**Glen Canyon Institute**  
**3090 East 3300 South, Suite 400**  
**Salt Lake City, UT 84109**

Re: Comments on Draft Environmental Impact Statement of Post-2026 Operational Guidelines and Strategies for Lake Powell and Lake Mead

Figure 3-8  
 WY Minimum and EOWY Elevations and Storage Volumes of Lake Powell

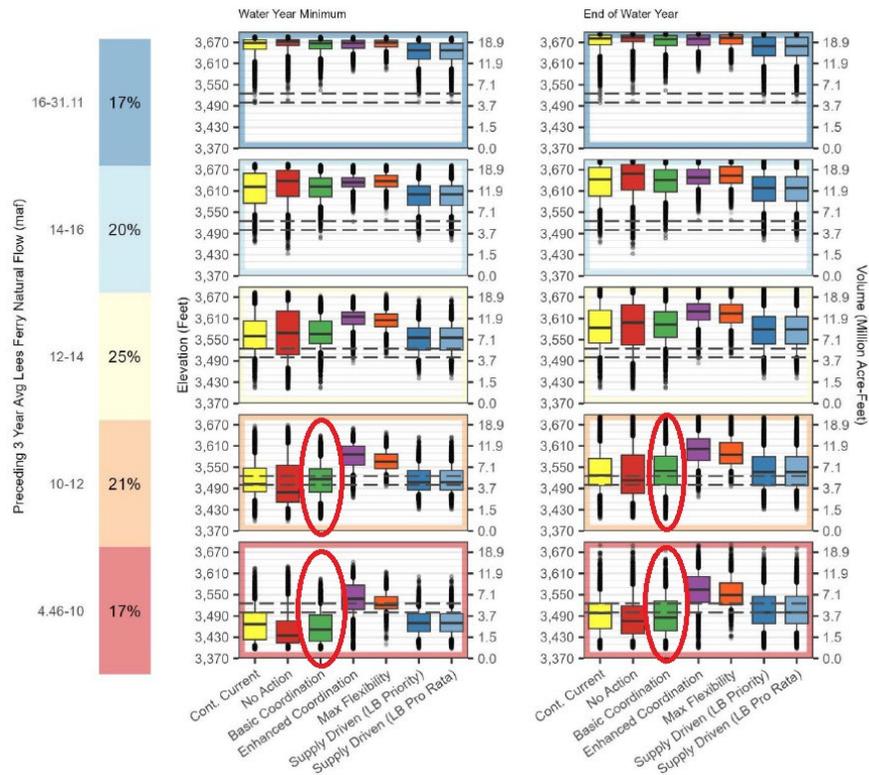
While dry hydrologies were in fact used in the DEIS modelling, **nearly every alternative still projects scenarios where Powell and Mead reservoirs drop below minimum power pool and deadpool, meaning they do not meet the purpose and need of the proposed action.** And given the absence of a state-led deal, we must assume that the likely preferred alternative will be a variation of the Basic Coordination Alternative, which under dry hydrologies (10-12 MAF natural flow) and extremely dry hydrologies (4.46-10 MAF), shows Lake Powell dropping below minimum power pool in a *high percentage* of scenarios. Given that initial conditions behind these models were developed some time ago and hydrological forecasts have been significantly downgraded, the risk of Powell crashing is much worse than what these models project.

Figure 3-8 from the DEIS shows that under the Basic Coordination Alternative, Lake Powell falls below powerpool in a large portion of forecasts. With recent hydrology worsening, the likelihood of Powell hitting and dropping below minimum power pool has increased significantly.

A group of Bighorn sheep stranded during a rapid rise in Lake Powell elevations in July of 2023.<sup>35</sup> Rising reservoir levels have extensive negative impacts on wildlife in GCNRA.

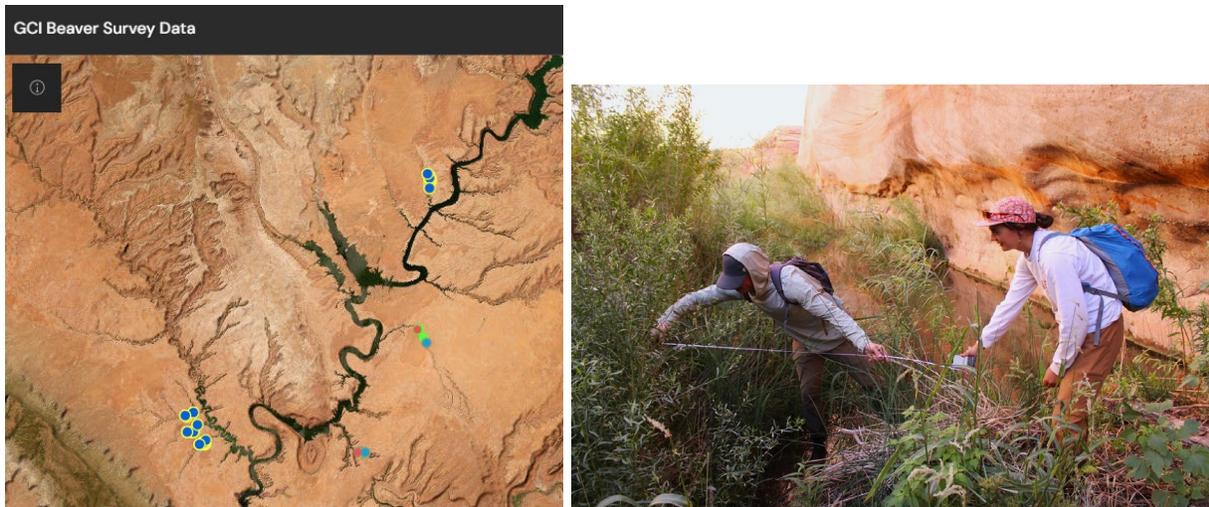
The impact analysis of wildlife in the Glen Canyon region erroneously assumes that higher reservoir levels at Lake Powell would be beneficial to wildlife in the region. **In fact, higher reservoir levels would destroy tens of thousands of acres of habitat for beaver, deer, Bighorn sheep, and other wildlife.**

## Native vs. non-native - all sites

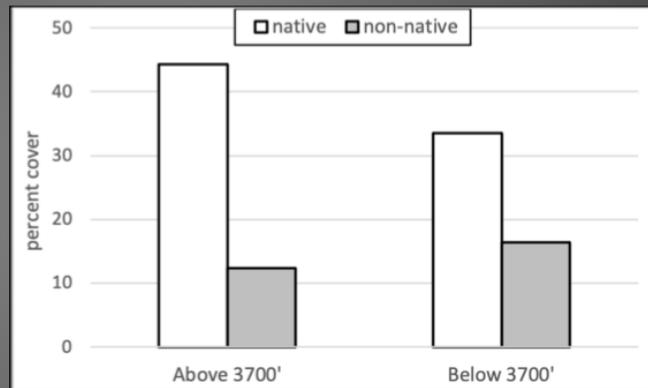
It is encouraging to see that the DEIS acknowledges these emerging habitats in section 3.9, stating, “native shrubs are outcompeting nonnative plants on sites that have been exposed for more than 3 years; these shrubs are providing diverse ecosystems, including hanging gardens and cryptobiotic crusts, where natural flow patterns are reestablishing (Arens 2023). Two special status plant species are present in the Lake Powell reach and could be affected by operations.”

But the impact matrix on page ES-41 contradicts the aforementioned characterization of riparian ecosystems that thrive when Lake Powell is at low levels. Performance in this matrix appears to be based simply on annual variability in water level fluctuations and assumes higher reservoir levels are good for Glen Canyon vegetation characteristics, while low water is bad. This assumption is undocumented and unsupported. **Lower reservoir levels are what allow for succession and diversity to continue; high reservoir levels kill that vegetation by inundating it (see images below).** The analysis misinterprets the Arens data cited, and fails to acknowledge that variability doesn't impact vegetation as much as absolute reservoir elevation.

Charts on Cataract Canyon vegetation above and below elevation 3700 ft. Seth Ares, WWA.

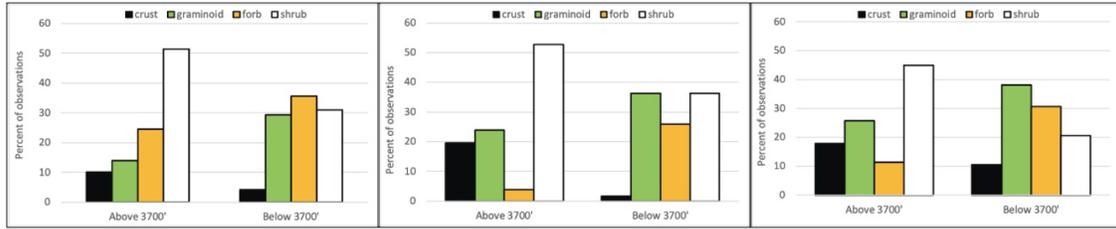
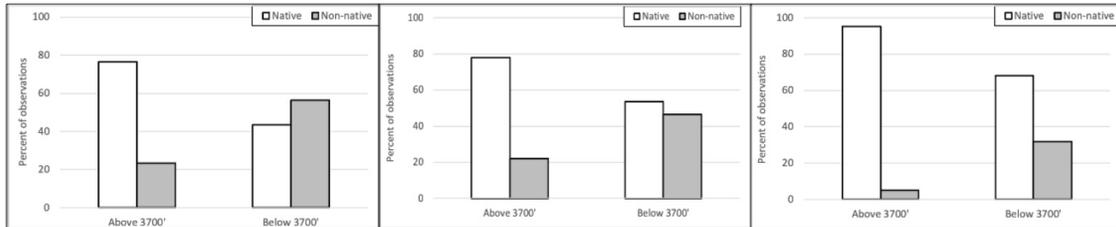
The vegetation surveys by Arens have shown a snapshot of what those plant assemblages look like from survey work at several sites at tributary canyons within Cataract.<sup>55</sup> A summary of the study states:

A map of flowing river miles within GNRA boundaries.<sup>57</sup>

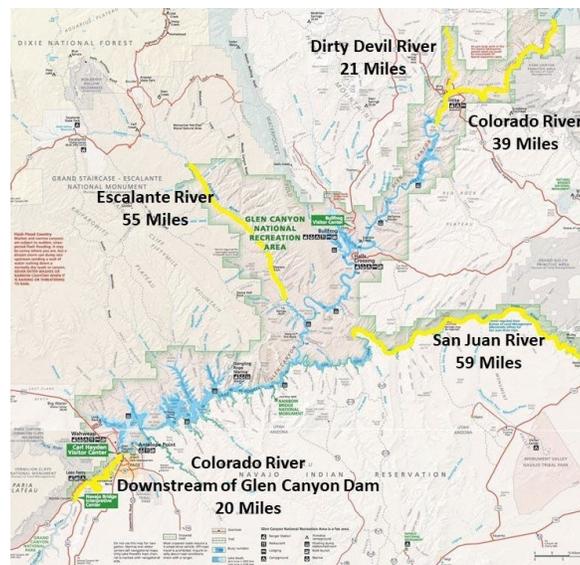
The statement and subsequent impact analysis fails to acknowledge the existence and economic value of whitewater rafting that takes place within the GCNRA boundary, specifically below the full pool elevation of 3,700 fsl. It only analyzes whitewater rafting below the dam, and omits the returned river corridor in Cataract Canyon and flowing river on the San Juan. **Glen Canyon National Recreation Area is, in fact, a park unit full of flowing rivers.** Within the boundaries of GCNRA, there are a cumulative ~190 cumulative navigable river miles (see figure below).

Referring to this area solely as "Lake Powell" and not Glen Canyon demonstrates that reservoir recreation is favored over river recreation or ecosystems. This section focuses on the potential impacts to reservoir and reservoir-based recreation. There is no mention of how to manage both the rivers *and* the reservoir in areas affected by management of Lakes Powell and Mead. In

Graphic showing sediment cross sections and waterfall formations on the San Juan River. Returning Rapids Project 2023 Field Binder.

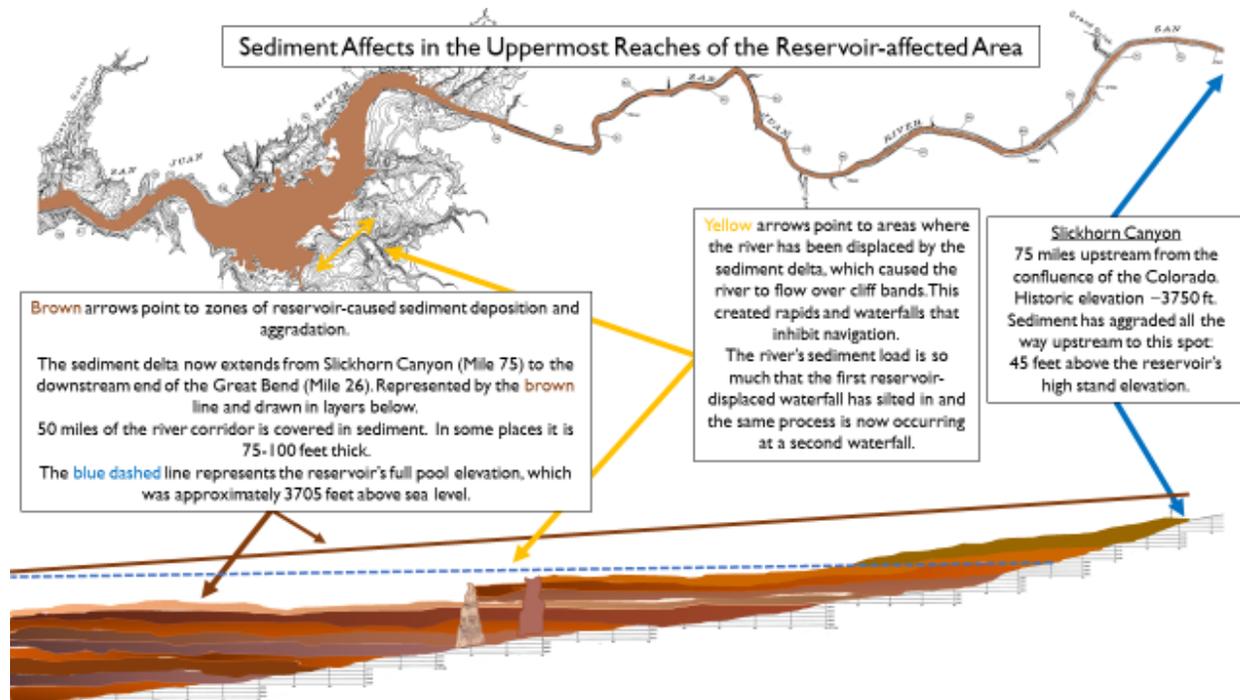
On the San Juan River, the original river channel has been displaced causing a waterfall at Paiute Farms, which will create challenges for future rafting recreation and ecological challenges. The lack of riverine ecosystem connectivity at the falls has impacts on native fish

populations, which is acknowledged in the impact analysis only as a function as a barrier preventing invasive fish from moving upstream. But the waterfall has blocked upstream sediment from the San Juan, impacting not just the newly flowing sections of river below Lake Powell's full pool level, but even causing river sediment to back up farther upstream.<sup>62</sup>

Any long-term operation plans must acknowledge how sediment is managed in Glen Canyon. This approach should address issues related to river/waterway access (river or reservoir), resource impacts, and resource remediation above areas where the reservoir will likely not be anymore. Understanding the sediment dynamics will allow the National Park Service, the Bureau of Reclamation, and the State of Utah to plan, fund, develop and manage infrastructure and public safety programs within Glen Canyon National Recreation Area. The recently completed USGS sediment survey of Lake Powell should form one of the elements of this assessment<sup>64</sup>.
